OUR REF: 18230

29 November 2019

**RE: SUPPLEMENTARY STATEMENT OF ENVIRONMENTAL EFFECTS (DA2019/0916)  
NO. 32 BOWER STREET, MANLY**

**Figure 1: Level 4 Floor Plan**

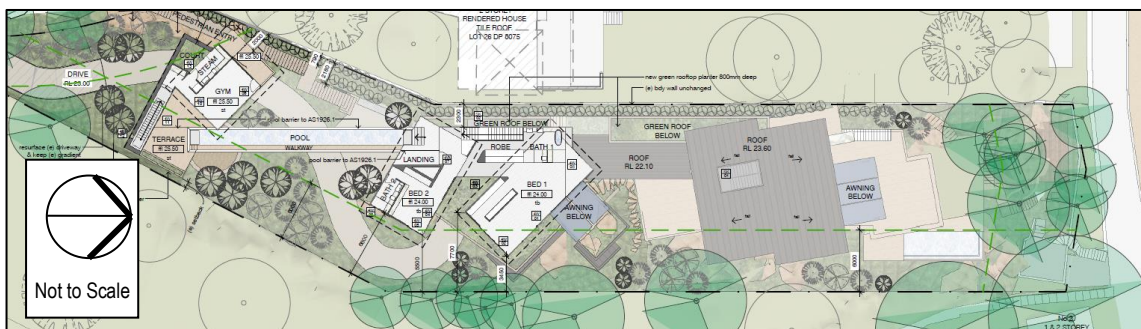
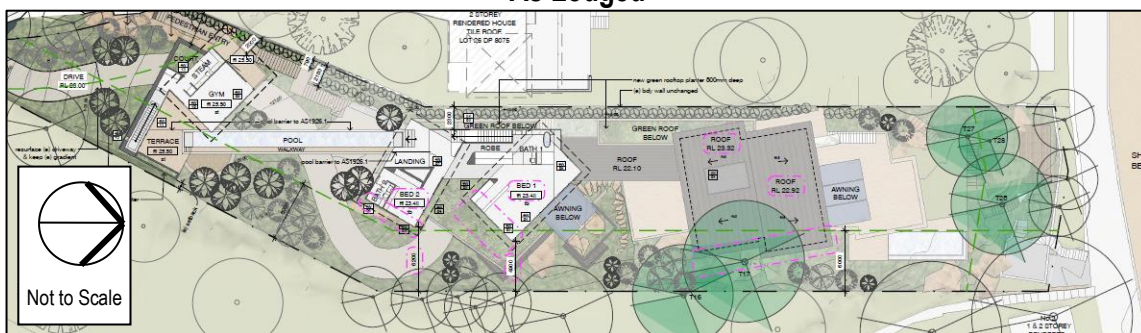
Level 4 is separated into three elements, connected by a lap pool and walkway. The proposed rooms and their uses are consistent with the lodged proposal, and the built form at the front of the site remains at RL 25.50 AHD. The landing area and adjoining rooms have been reduced by 520mm from RL 24.00 AHD to RL 23.48 AHD; and the roof at the lower portion reduced by 680mm from RL 23.60 AHD to RL 22.92 AHD, to accommodate the lowered building height (see Figure 1).

The extent of Bedroom 1, Bedroom 2 and Bathroom 2 have been reduced, with increased setbacks to the eastern boundary minimising encroachment on the 6m buffer to the adjoining reserve (see Figure 1). Bedroom 1 setback has increased from 3,450mm to 4,900mm, and Bedroom 2 setback has been increased to 6,200mm. Bedroom 2 is now outside the 6m reserve setback.

**Figure 2: Level 3 Floor Plan**

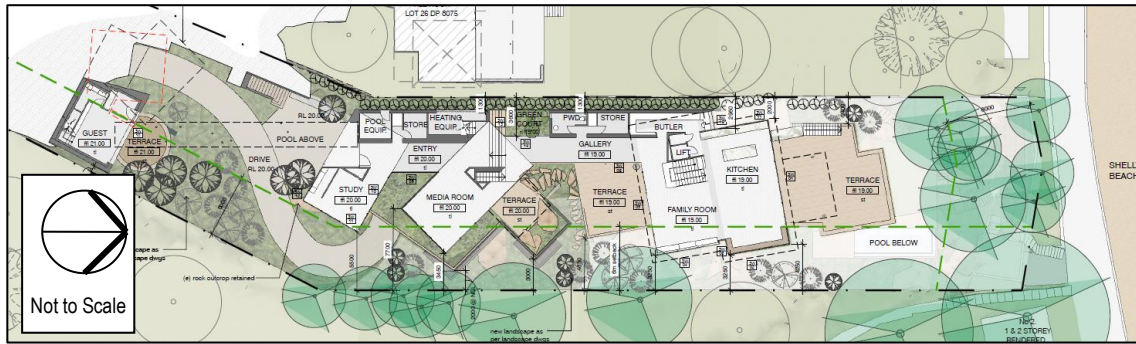
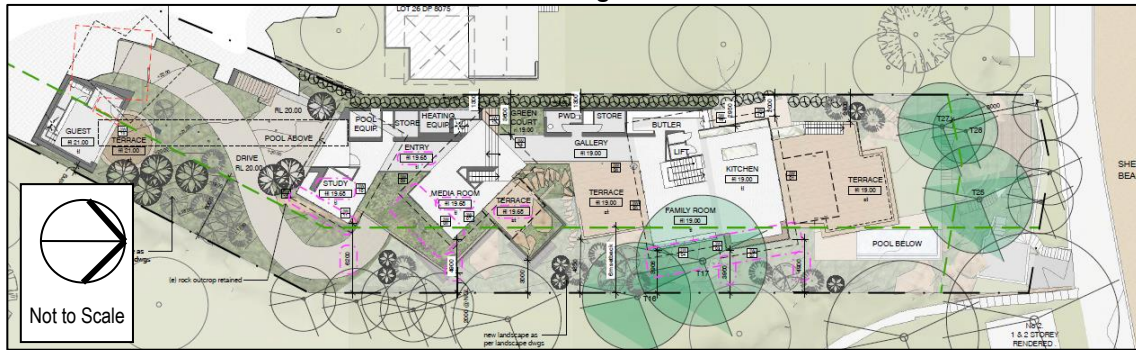
Level 3 is split into several elements. Similarly, the proposed rooms and their uses are consistent with the proposal. The built form at the front of the site remains at RL 21.00 AHD. Further down the site, the main dwelling entry, study, and media room portion has been lowered from RL 20.00 AHD to RL 19.68 AHD. The final element to the rear of the site remains at RL 19.00 AHD (see Figure 2 on the following page).

The extent of the media room and study have again been reduced, as per Bedroom 1 and Bedroom 2, with increased setbacks to the eastern boundary minimising encroachment on the 6m buffer to the adjoining reserve. The study is now outside the 6m reserve setback (see Figure 2 on the following page).

**Figure 3: Level 2 Floor Plan**

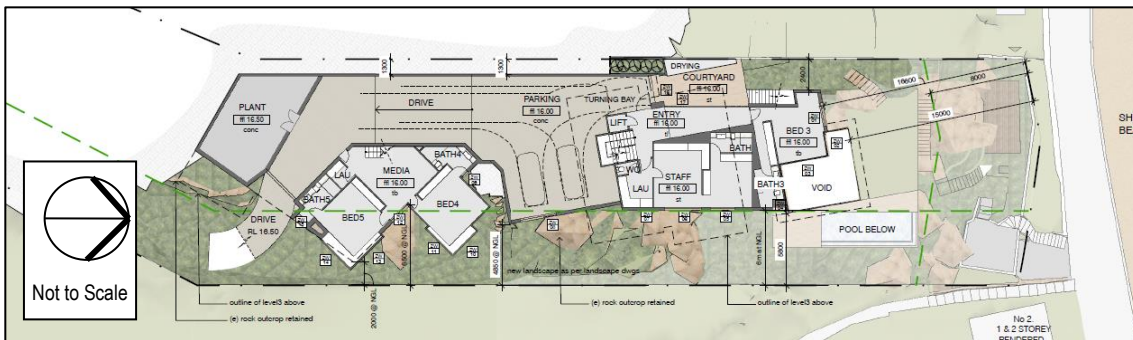
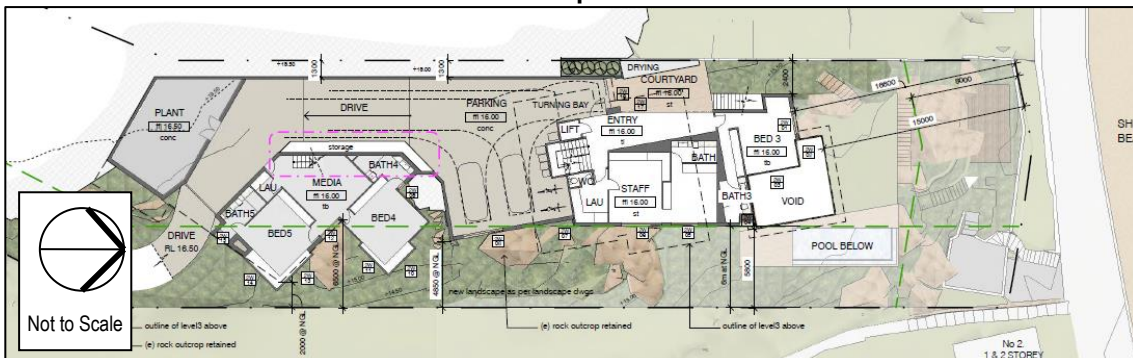
Level 2 remains at RL 16.00 AHD and RL 16.50 AHD. The proposed rooms and their uses are consistent with the proposal. The only changes at this level are an additional storage area, adjoining the driveway; and two bicycle parking spaces to meet Council’s DCP requirements (see Figure 3).

**Figure 4: Level 1 Floor Plan**

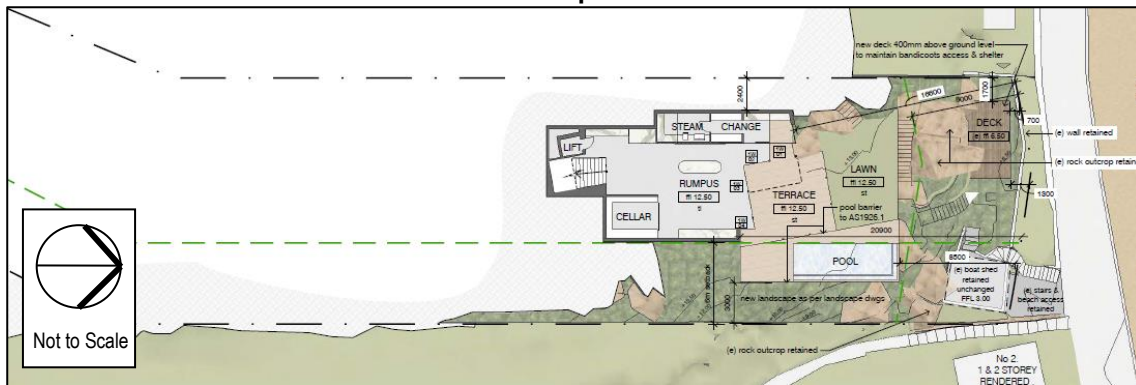
Level 1 remains at RL 12.50 AHD towards the rear of the site. The proposed rooms and their uses are consistent with the proposal (see Figure 4).

**Figure 5: Height Blanket showing the Amended Heights**

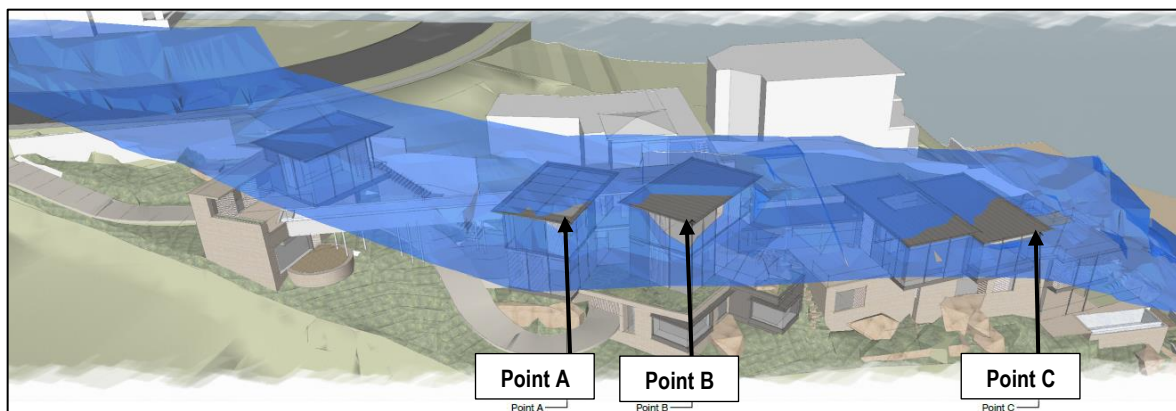
The new dwelling will have building heights of between 6.5m and 10.89m, with majority of the dwelling compliant with the control. The building height at Point A is 9.28m; at Point B is 10.89m; and Point C is 8.46m – 9.46m, (see Figure 5).

**Figure 6:** Eastern Elevation showing Proposed and Amended Height in comparison to Previously Approved Height

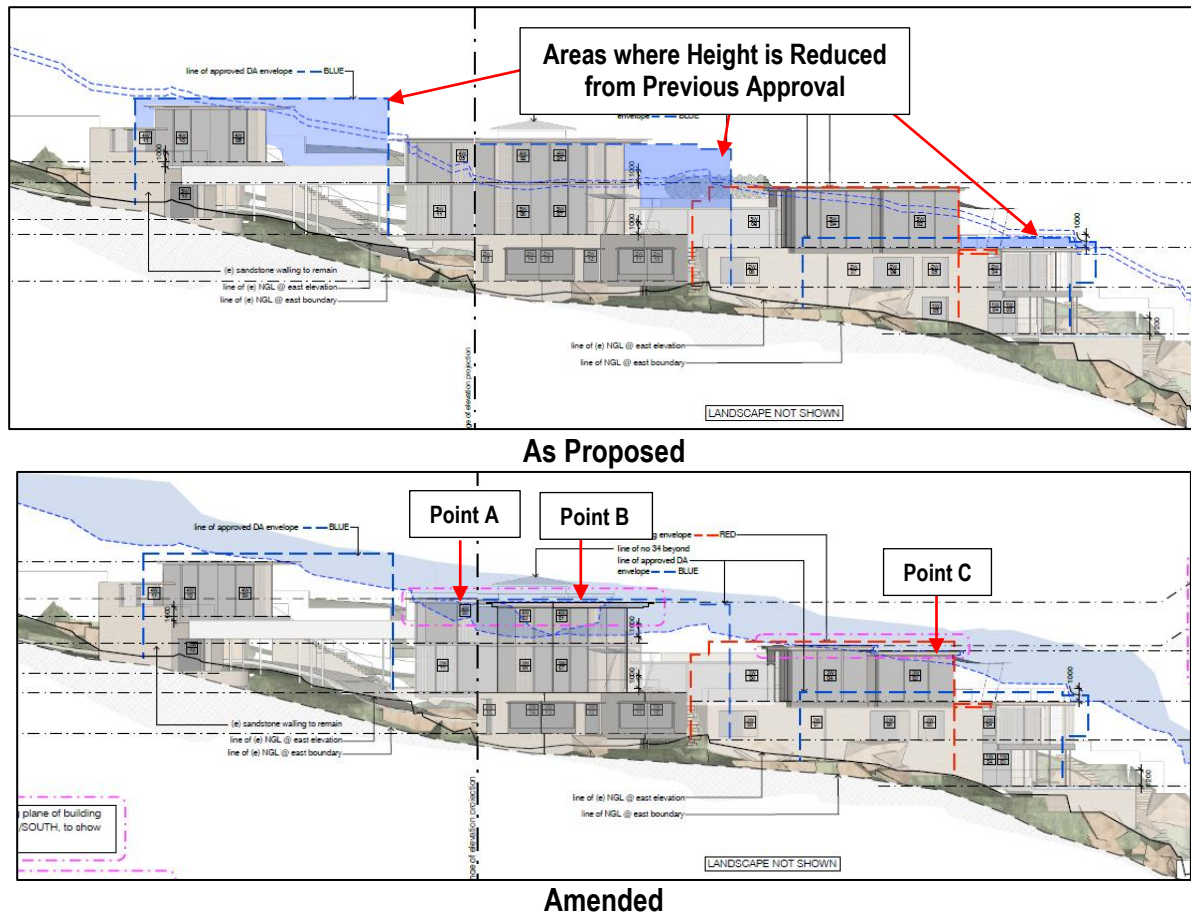
The proposed amended new dwelling reduces the previously approved development's building height, which had a maximum height of approximately 11m. It will continue to maintain views from No. 34 Bower Street (see Figure 6).

**Figure 11: Existing and Amended Proposed Built Areas within 6m Setback Zone**

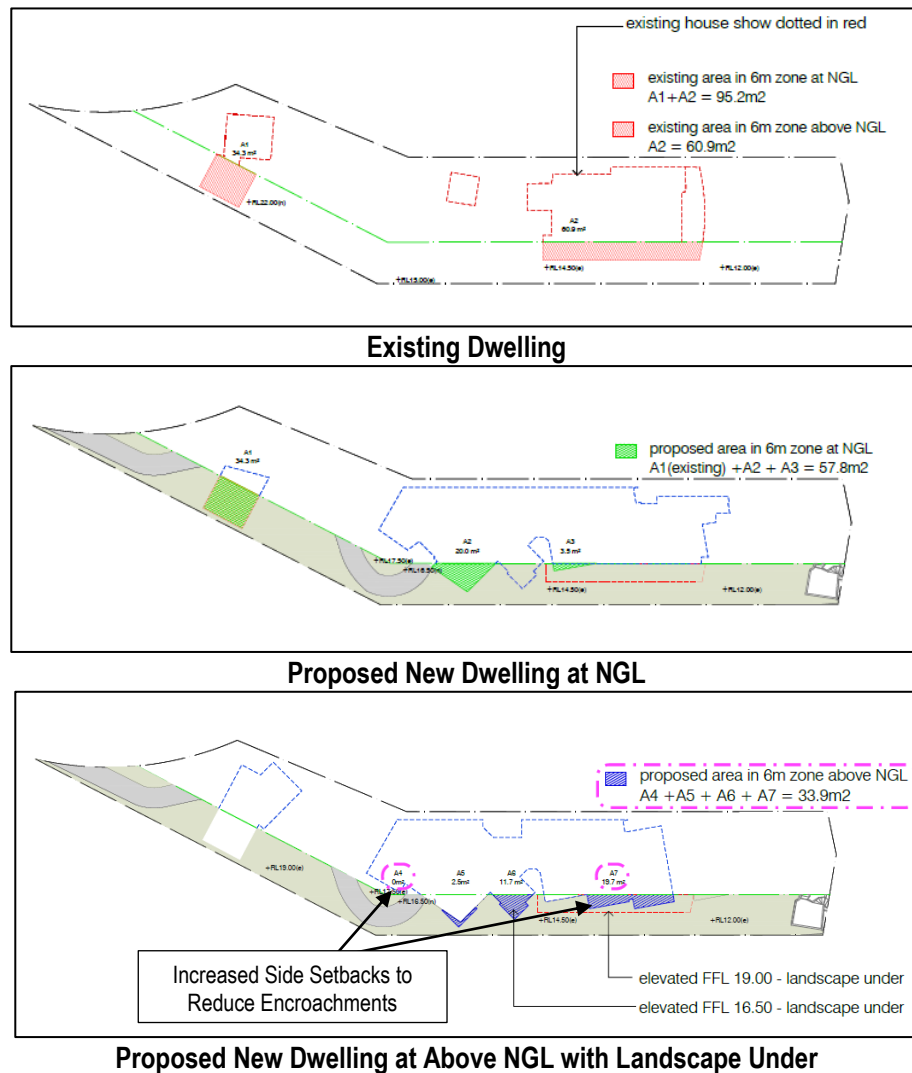
The existing lot is approximately 18.75m wide along the portion where the current dwelling is constructed. The required 6 metre setback to the reserve on the eastern side is almost one third of the site's width (see Figure 11 on the following page). Required setbacks on the western side are 1/3 of the wall height, which vary according to the wall heights. The proposed western side setback is generally no less than 1.3m, which is the same as existing. The side setback on eastern side ranges from 2.0m to 6.2m to the adjoining reserve, similar or less than the existing dwelling. The Level 3 & 4 setbacks are an improvement on the original proposal.

**Response:** The amended proposal's form is a reaction to the long, linear shape of the site which would otherwise result from application of the 6-metre open space/reserve setback control on the eastern side. The amended proposal will reduce encroachments within the 6m eastern side setback zone at ground level, an improvement on the originally proposed and existing situations (see Figure 11 on the following page).

**Figure 14:** Original and Amended Proposed View Impact Diagram, as viewed from The Roof Terrace of No. 43 Bower Street

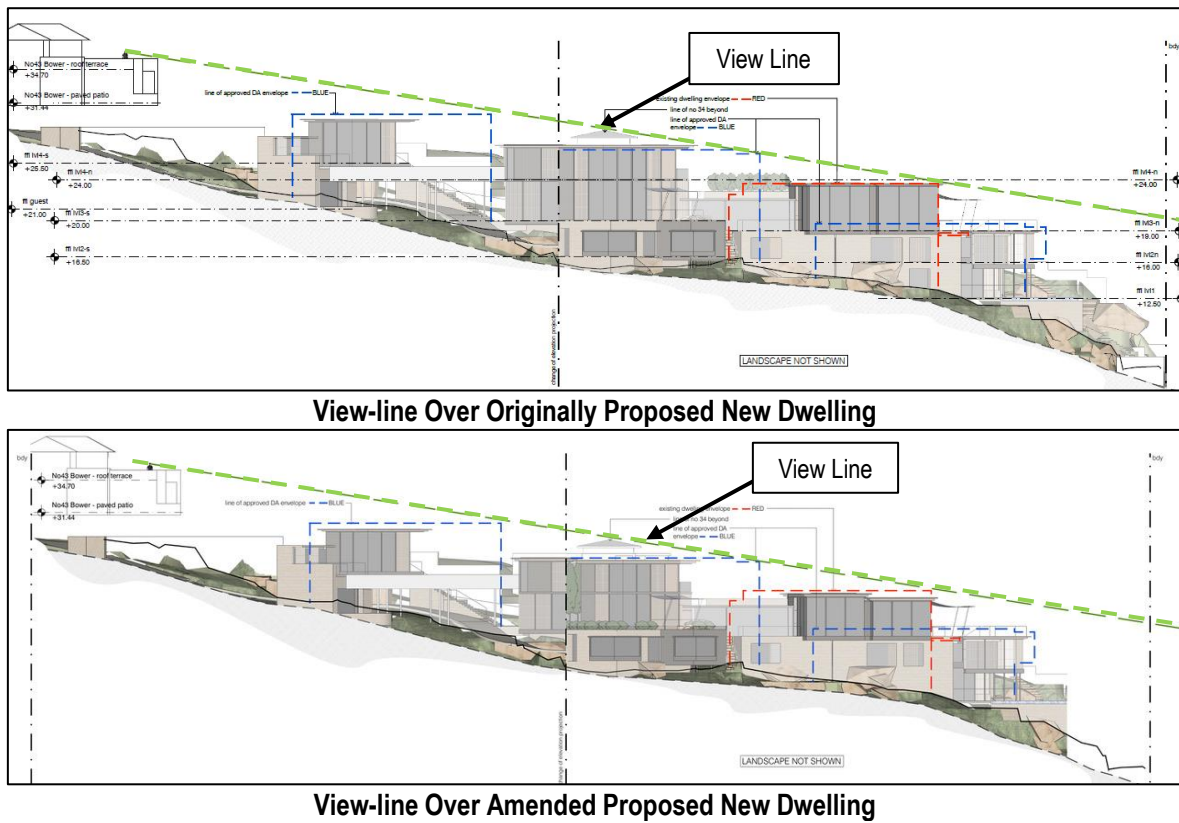
As discussed in the initial SEE, minimising view loss from the neighbouring property at No. 34 Bower Street has been an important consideration and is addressed by relocating the built form further south from the neighbour's living areas; maintaining a stepped height; and flat roof forms. This, coupled with a reduction in building height compared to the original proposal and previous approval, provides significantly less intrusive impacts and maintains existing ocean views enjoyed from the living room and balcony of No. 34 Bower Street (see Figure 14 on the following page).
